## Service Bulletin

### Improved cable rolling mechanism for power cord introduced

| <b>Title:</b>             | DX-D 100 - SB120 - Improved cable rolling mechanism for power cord introduced |

Figure 3

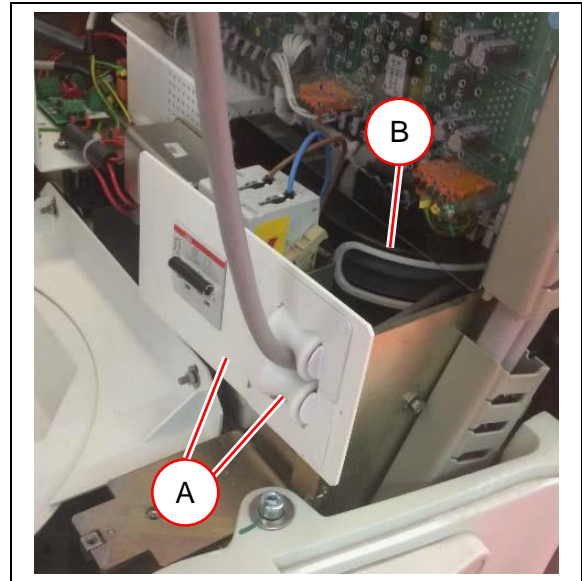
An improved cable rolling mechanism for the power cord is available.

It consists of:

- New plate with rollers (A) and
  - Cable reel with big window (B).
- The reel with the big window was already introduced in November 2017.

The new cable rolling mechanism is introduced in production in January 2020.
